5 SUBDIVISION OF LAND (6 LOTS) AT 44 AMBROSE STREET, EMERALD

FILE REFERENCE INT1691152

APPLICATION NO.:	T160026
APPLICANT:	Julie Kowalski C / - Nobelius Land Surveyors
LAND:	Lot S3 PS325761 44 Ambrose Street, Emerald Victoria 3782
PROPOSAL:	The subdivision of land into six (6) lots in three (3) stages and creation of a road and the removal of vegetation
PLANNING CONTROLS:	Low Density Residential Zone –Schedule 1 Bushfire Management Overlay Design and Development Overlay – Schedule 1 Vegetation Protection Overlay – Schedule 1
NOTIFICATION & OBJECTIONS:	The application has been advertised pursuant to Section 52 of the <i>Planning and Environment Act 1987</i> , by sending notices to adjoining land owners and occupiers. Council has received 10 objections to date.
KEY PLANNING CONSIDERATIONS:	Lot size, noise, traffic, amenity issues, vegetation removal
RECOMMENDATION:	Notice of Decision

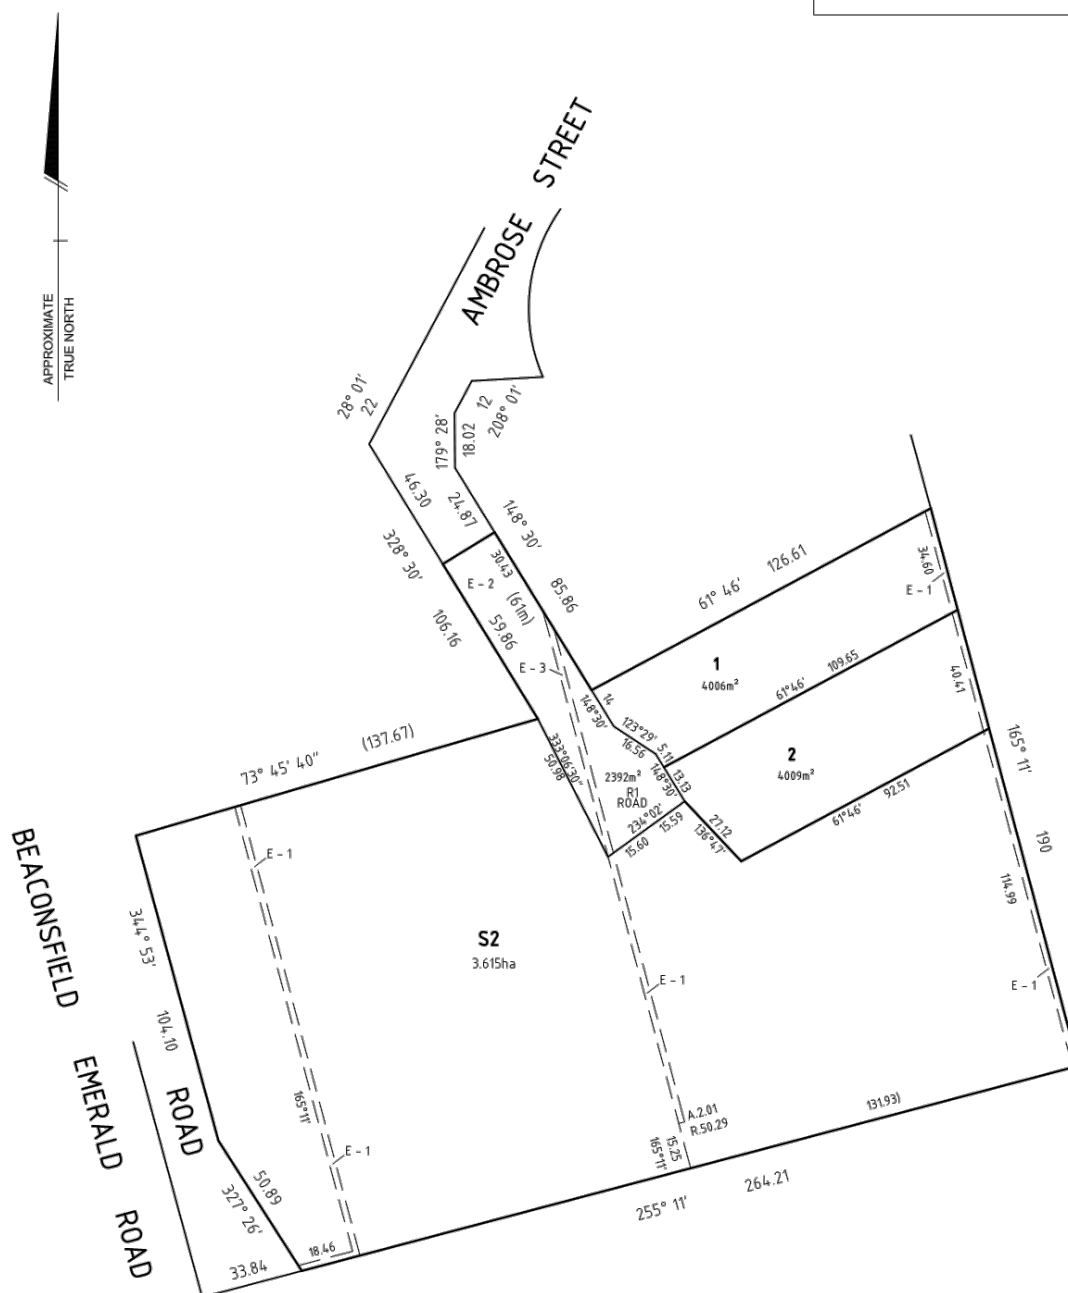
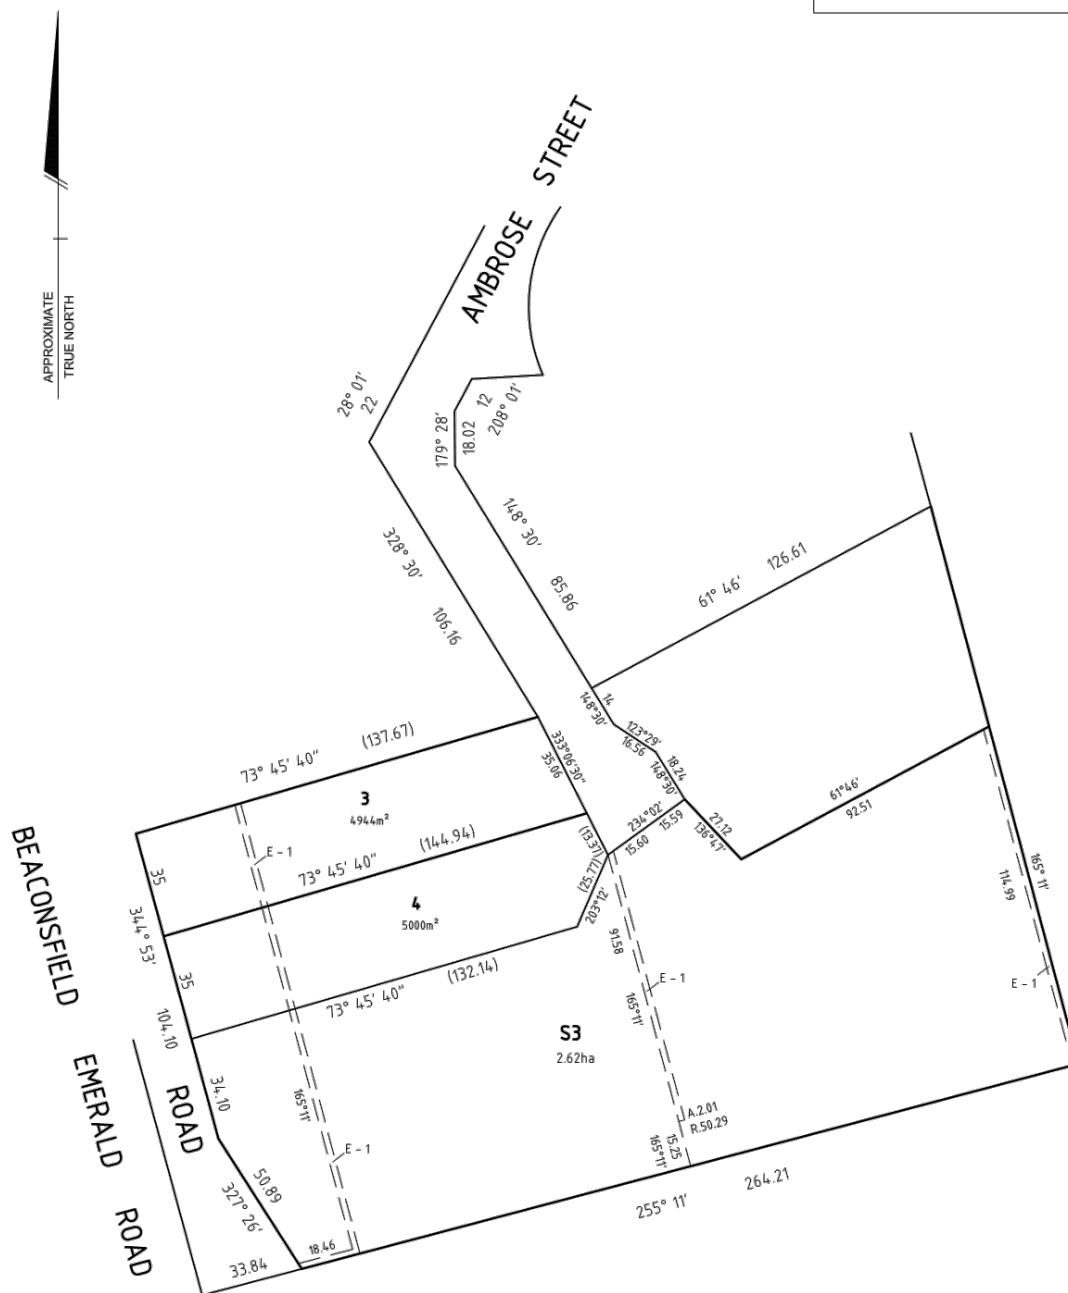
- c) Amended building envelope plan demonstrating the building envelopes to be located in accordance with the lots arrangement on Version 5 of PS727455. Building envelopes must be sited to ensure vegetation to the rear of proposed Lot 1 and 2 are retained.

- a) The roadway indicated as 'R1' on the plan of subdivision must be fully constructed with a sealed pavement and kerb & channel,
 - b) Underground drainage must be constructed to appropriately drain the proposed lots and road reserve.

- c) Concrete vehicle crossings constructed to service all proposed lots.
 - d) A court head construction that accommodates the turning movements of an 8.8 metre garbage truck.

b) Show for Lot 6 an area of defensible space around the proposed building envelope for a distance of 11 metres in the north, south and east directions and to the property boundary in the west direction.
